**CITY OF NEWBURYPORT**  
DEPARTMENT OF PUBLIC SERVICES  
16A PERRY WAY  
NEWBURYPORT, MA 01950

**Phillips Drive Neighborhood Drainage and Flooding Problems**  
**Evaluation Report and Recommended Solutions**

January 2018

CHERRY HILL DRAINAGE - EXISTING WATERSHED  
REPORT

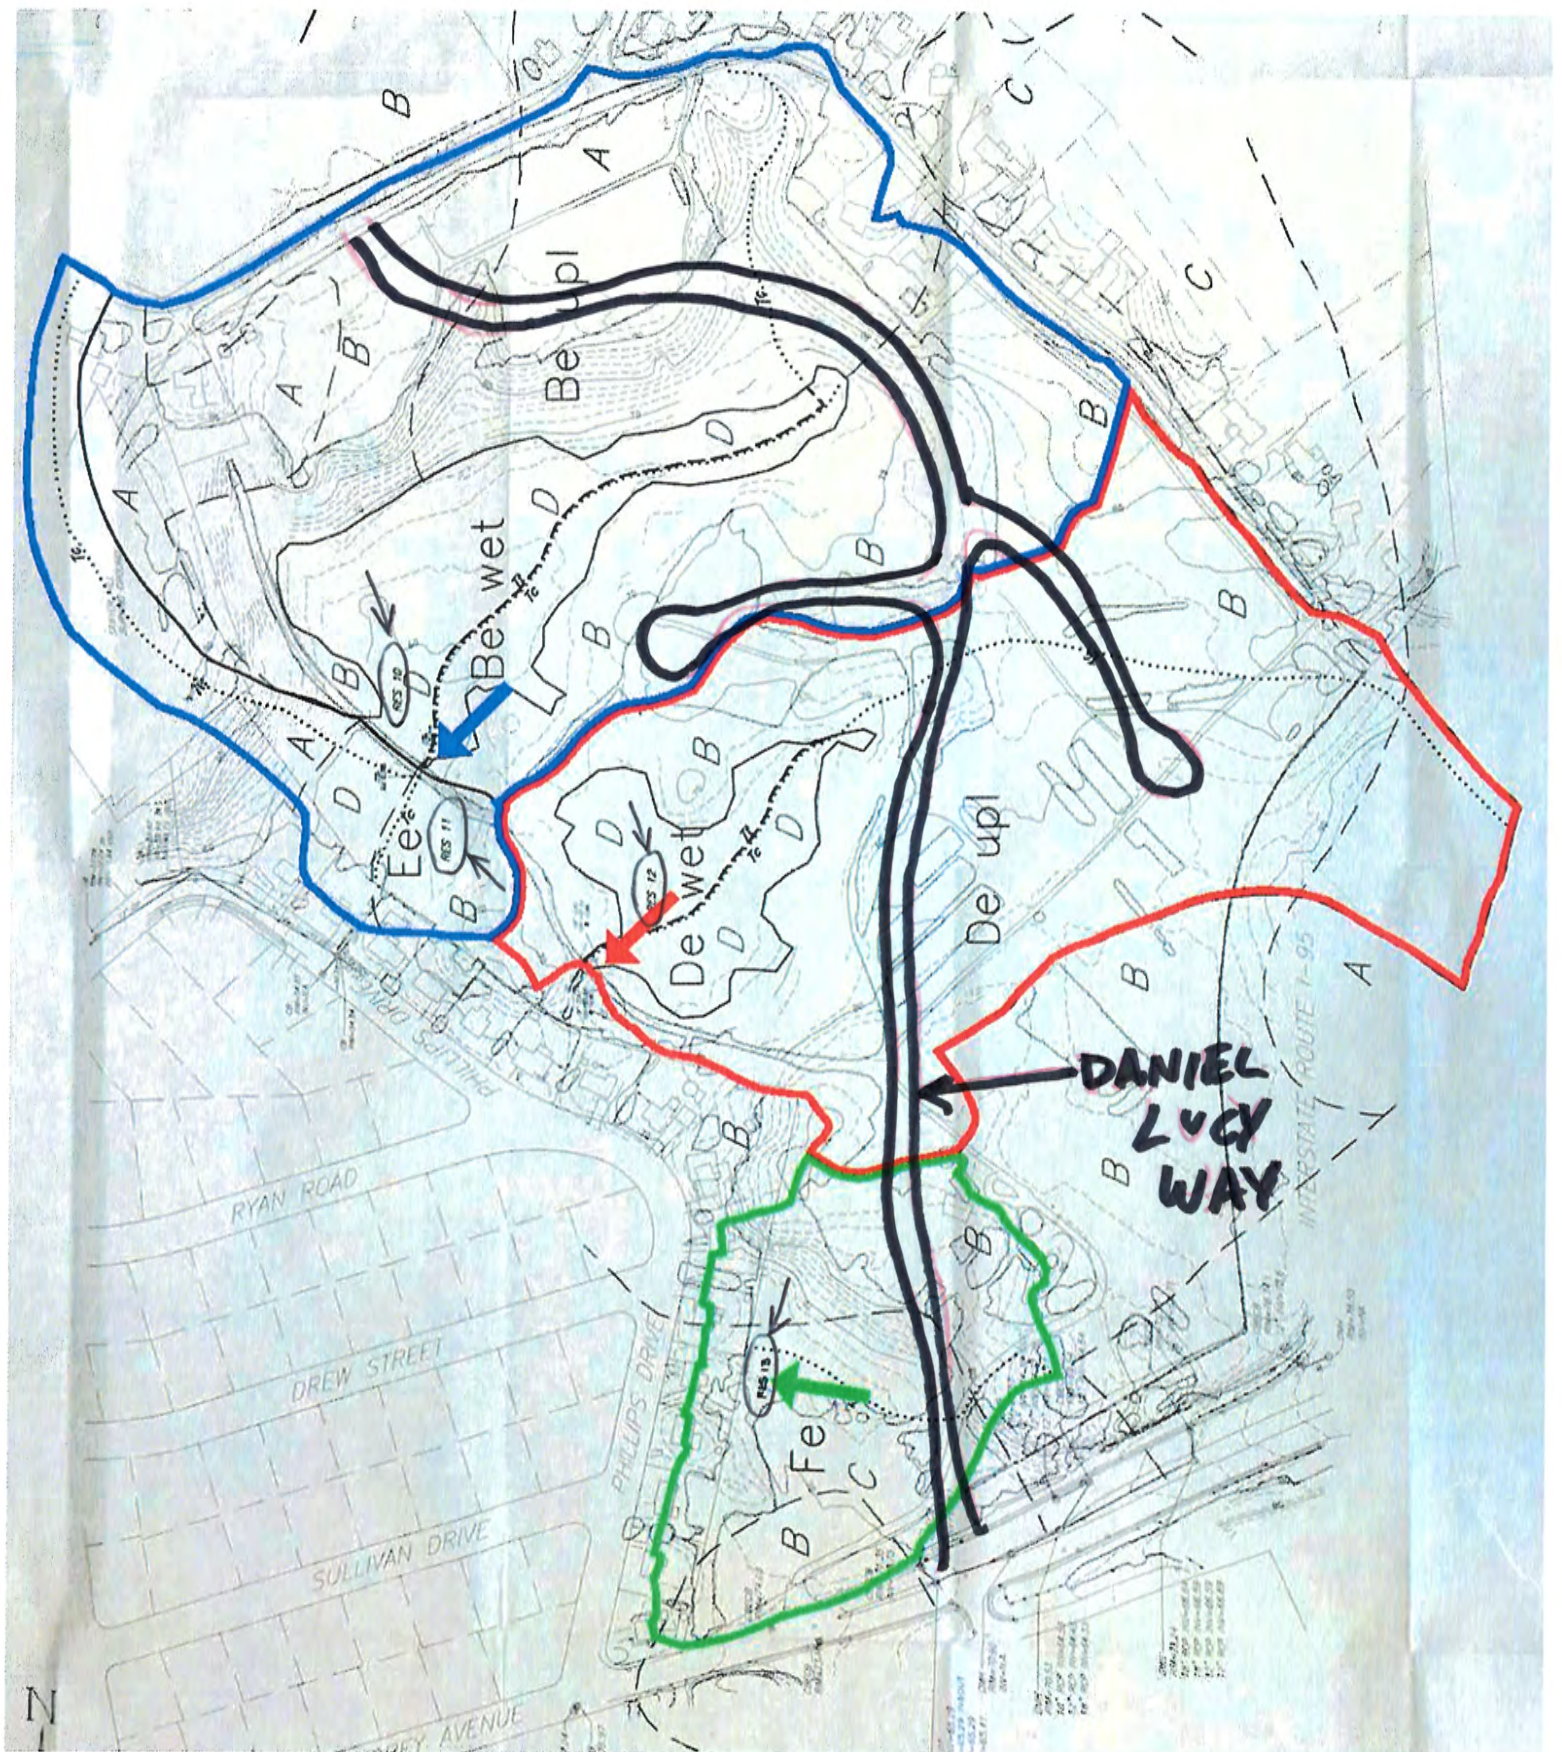
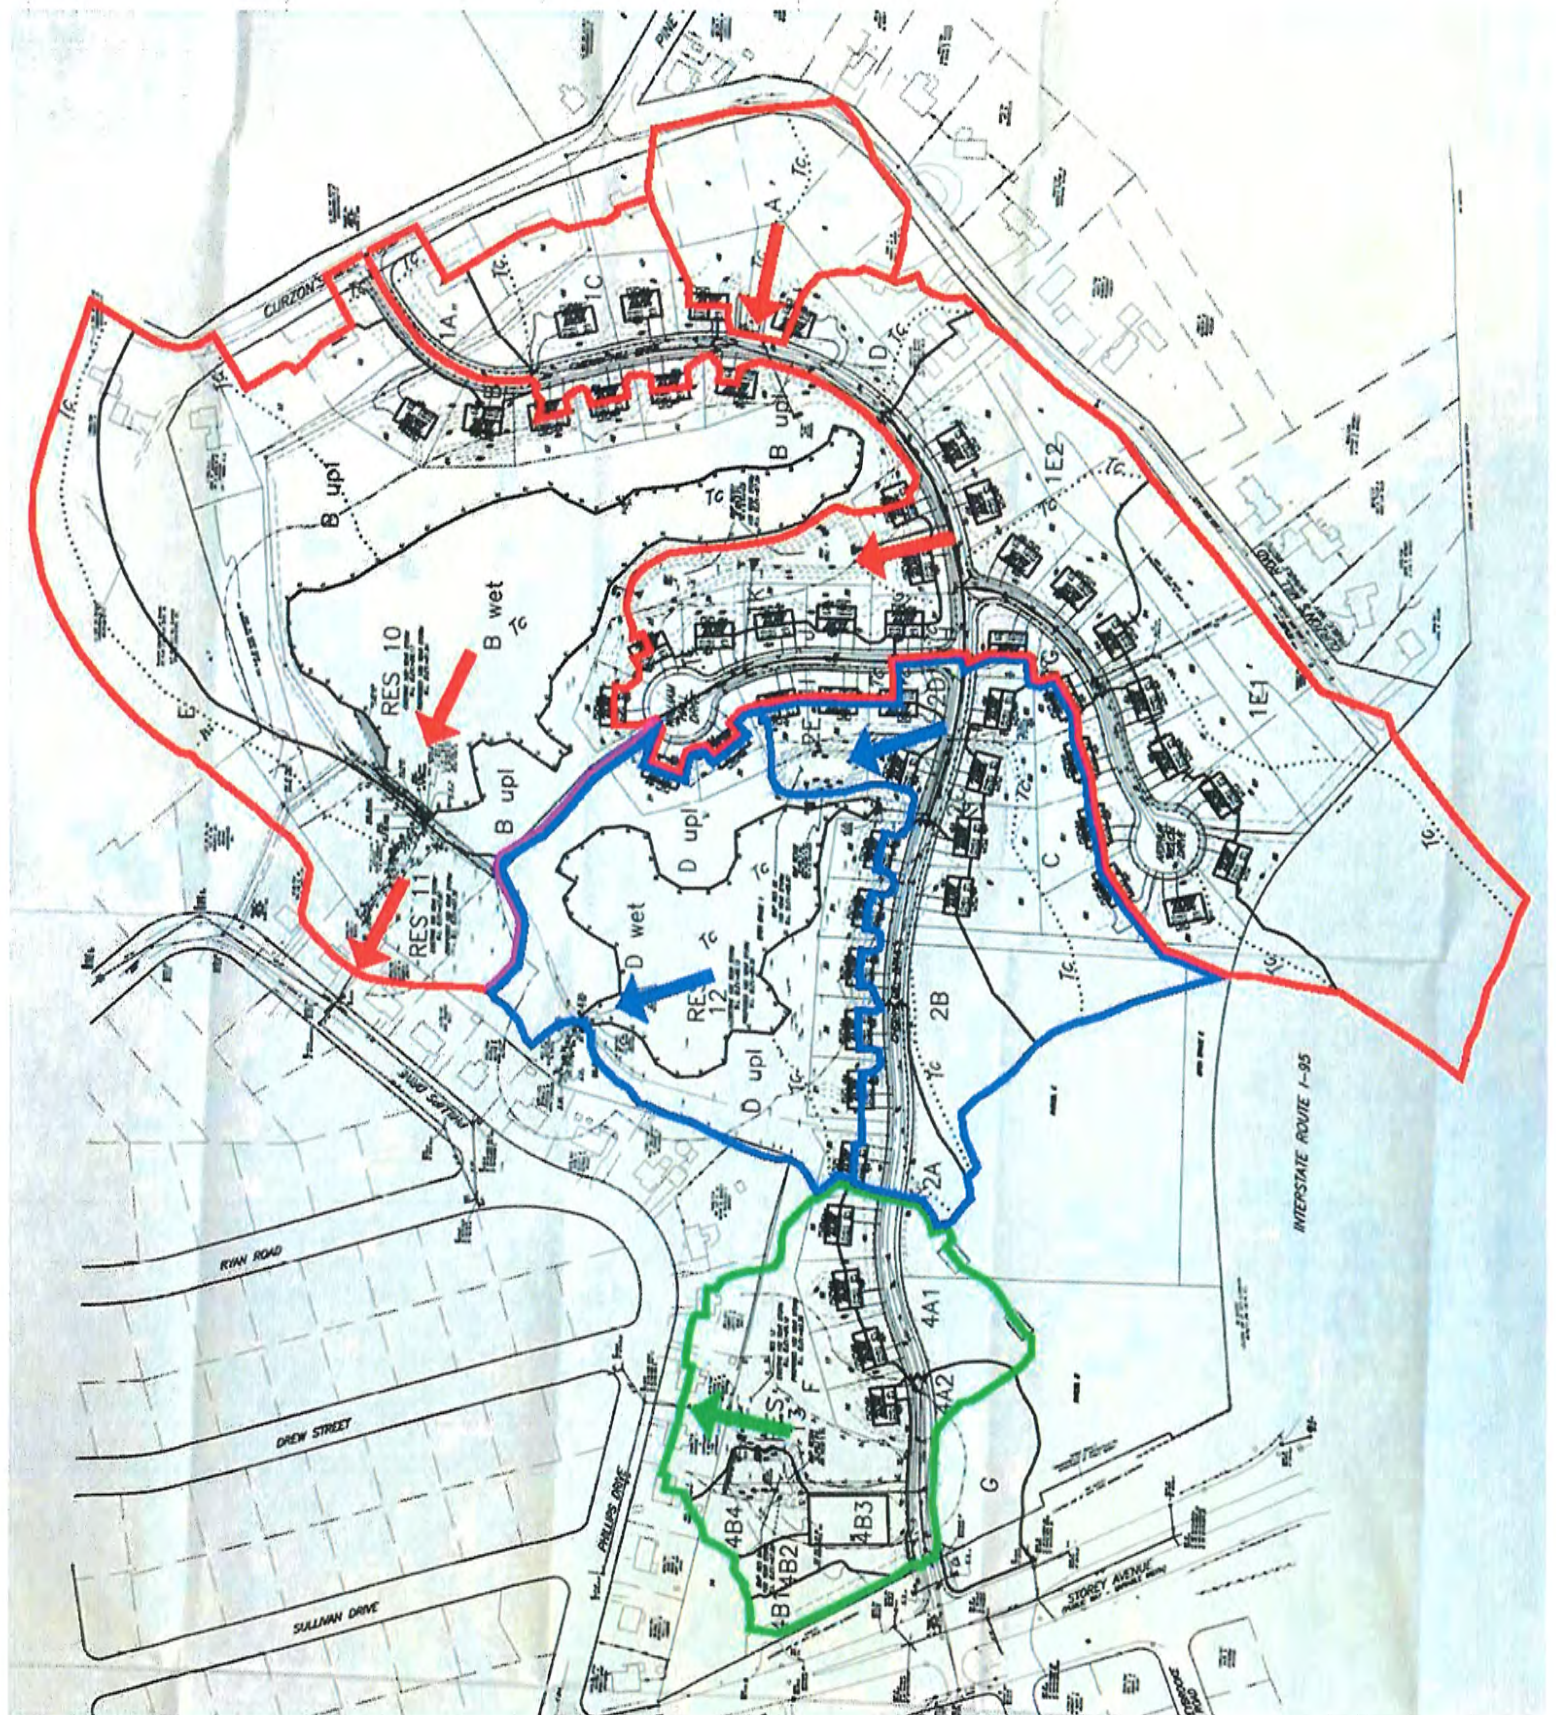
For the existing conditions (pre-development conditions) the engineer used runoff coefficient factors of 44, 49, and 54 for two largest watershed areas (Be upland, De upland, and Ee, as shown on Existing Watershed plan in Appendix B). These numbers are composite (weighted average) runoff coefficient factors because the areas include both the tree farm and wooded areas. The range of coefficient factors used by engineers performing TR-20 hydrologic models starts on the low end with 30 for forests in healthy condition (i.e. thick vegetated sponge) and tops off at 98 for pavement (i.e. nearly 100% runoff).

We find the runoff coefficient numbers used by the engineers to be acceptable.

- We did not find any substantial errors in their calculations (measurements of land areas, improper use of hydrologic formulas, etc.).

- The engineer released the runoff from the development towards three separate discharge points – all of them discharging into Phillips Drive and are labeled as “RES-#”. The **rate of runoff** from the three discharge points under post-development conditions were greatly reduced when compared to pre-development conditions. See attached summaries in Appendix B.

From Cherry Hill Subdivision Plans. Shows locations of where the following pictures were taken.

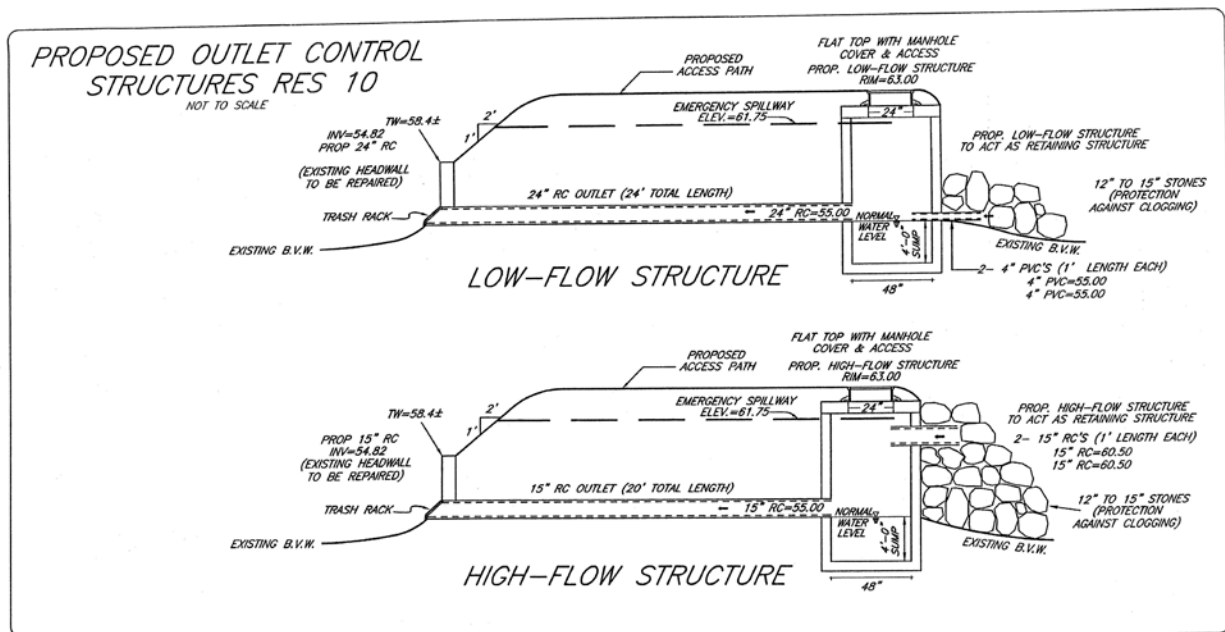
Picture 1: Fall 2017. Standing at the base of the berm/road looking northwest – road on left, detention pond on right. Notice drain manhole structure top left and stone in front of it.

Design sketch from Cherry Hill Subdivision Plans. The outlet control structure is a drain manhole with two pipes collecting flow from the pond.

The top picture shows that the inlet pipes are completely buried and are not functioning as designed (the bottom sketch). The stone is too small and the voids have since clogged preventing direct flow of runoff to pass downstream.

Picture 2: Two outlet pipes downstream of the road/berm. Pipe to right completely clogged.

Picture 3: Inlet of 12" pipe behind 37 Phillips Drive. This pipe collects all the discharge flows from Cherry Hill's detention pond RES 10.

Description: Unclog the outlet pipes from Cherry Hill's detention ponds. See Appendix D.
